**Subject** Amendment No. 8 Architectural Services Agreement –LCA Architects – Fremont High School New Construction Project - Division of Facilities Planning and Management

## AMENDMENT NO. 8

### ARCHITECTURAL SERVICES AGREEMENT

This Amendment is entered into between the Oakland Unified School District (OUSD) and LCA Architects. OUSD entered into an agreement with CONTRACTOR for services on **March 13, 2016** ("Agreement"), and the parties agree to amend the Agreement for the Services with **Fremont New Construction Project** as follows and in the attached Exhibit A:

### Bulletin Revision Issues

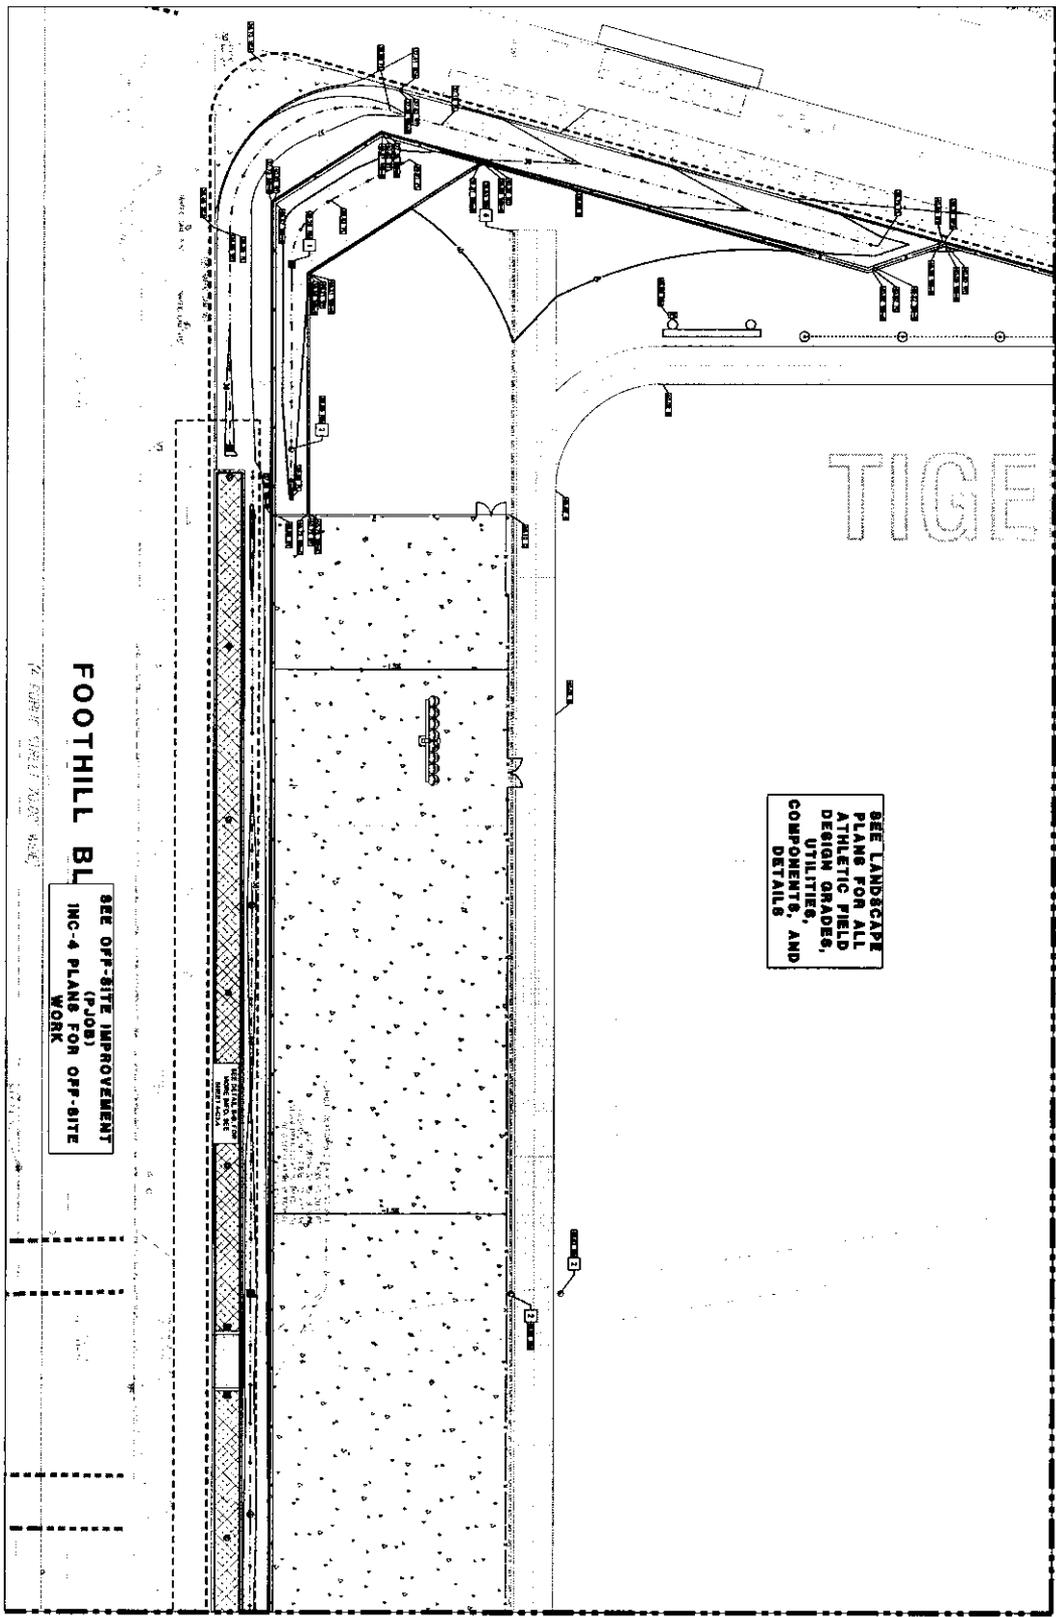
- Revised bulletin 4-004.1 adds two plumbing sheets (4-P2.01 and 4-P2.02) documenting revisions in response to RFI 4-037.1 and RFI 4-044 related to furring behind urinals and piping outside of walls.
- This bulletin provides revised civil utility plans and underground plumbing plans in response to the following RFI's: 4-039 Plumbing Stub Outs, 4-040 FSR Location (see also CCD 4-003 pending DSA Approval), 4-045 Storm Drain, 4-049 Conc Duct & SD, 4-050 Utility Pole & SD.

- Grading and Drainage Sheets: 4-C3.0, 4-C3.1, 4-C3.2, 4-C3.3, 4-C3.4

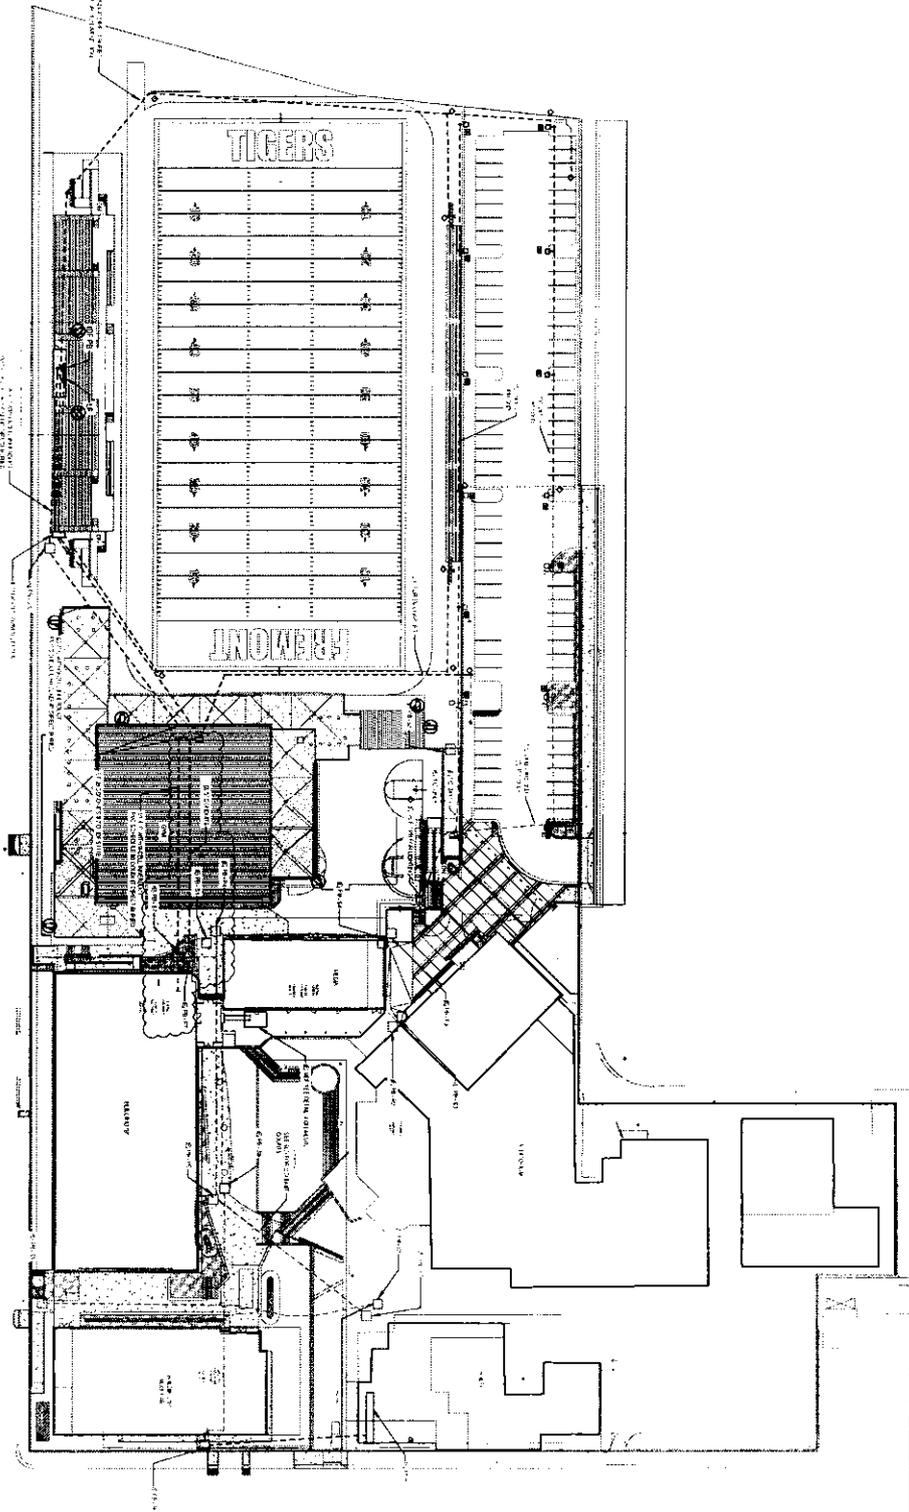
Summary: **This bulletin provides revised grading plans, in coordination with storm drain design issued as part of Bulletin 4-004.3.**

- Sheets 3-A2.01, 3-A2.02

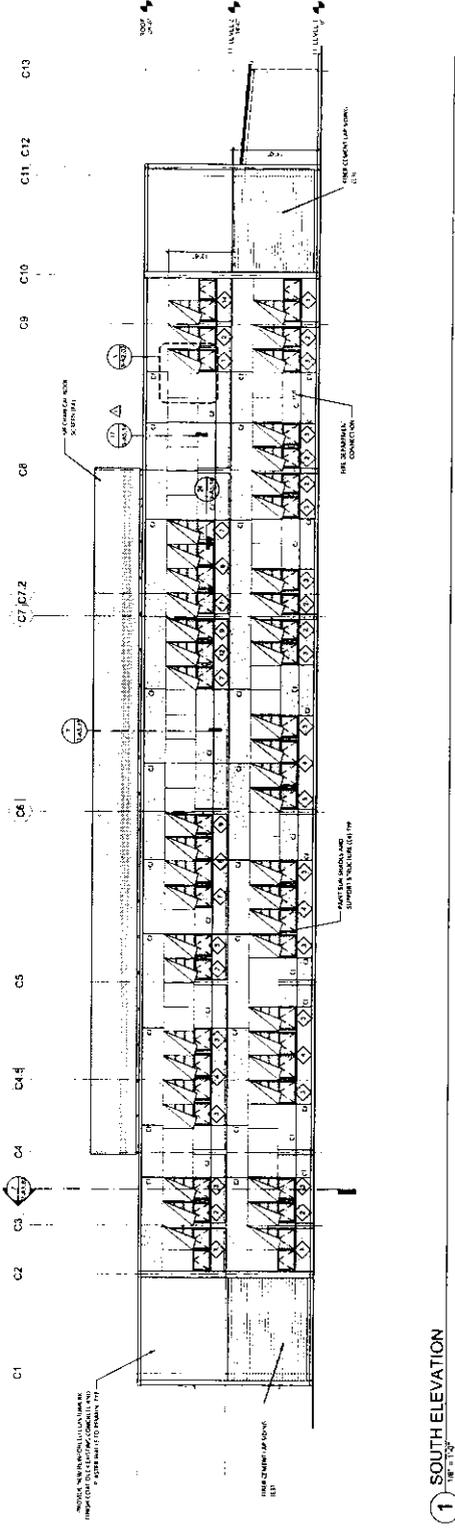
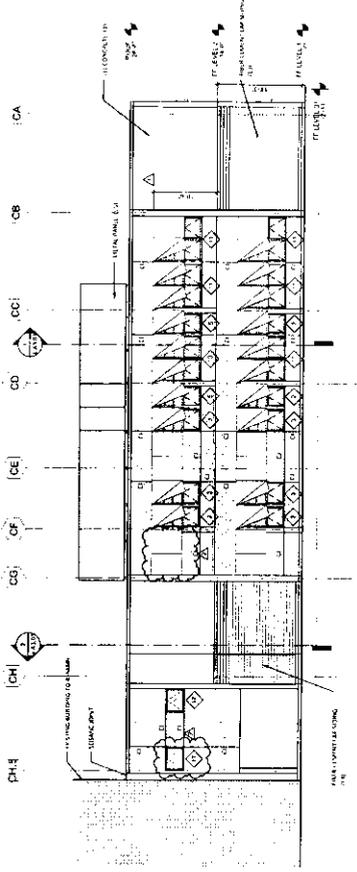
**3-006.1 adds Sheet 3-A2.01 and identifies control joints on both elevation sheets. The other sheets are unchanged.**

3 TELECOM ROOM IDF 1118 AND IDF 1215 - RACK ELEVATIONS

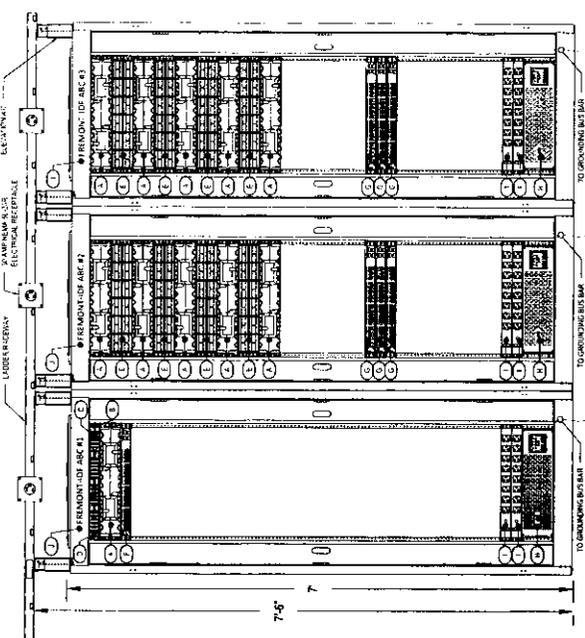
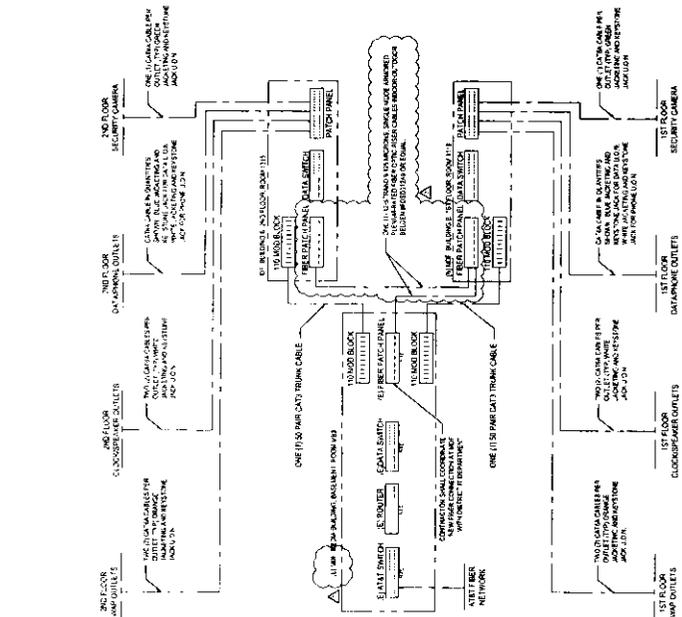
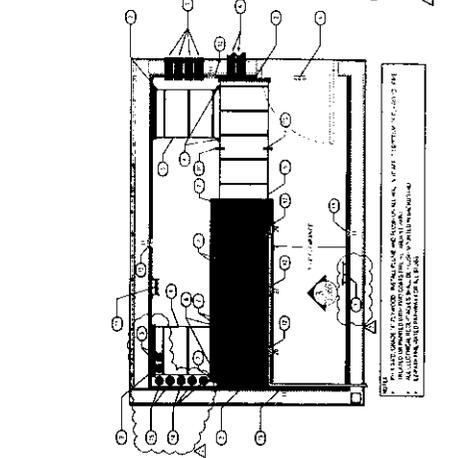
Summary: This bulletin provides site electrical plan w/ revisions for power & signal to stadium scoreboard and clarification of pathways to IDF in Wellness Clinic.
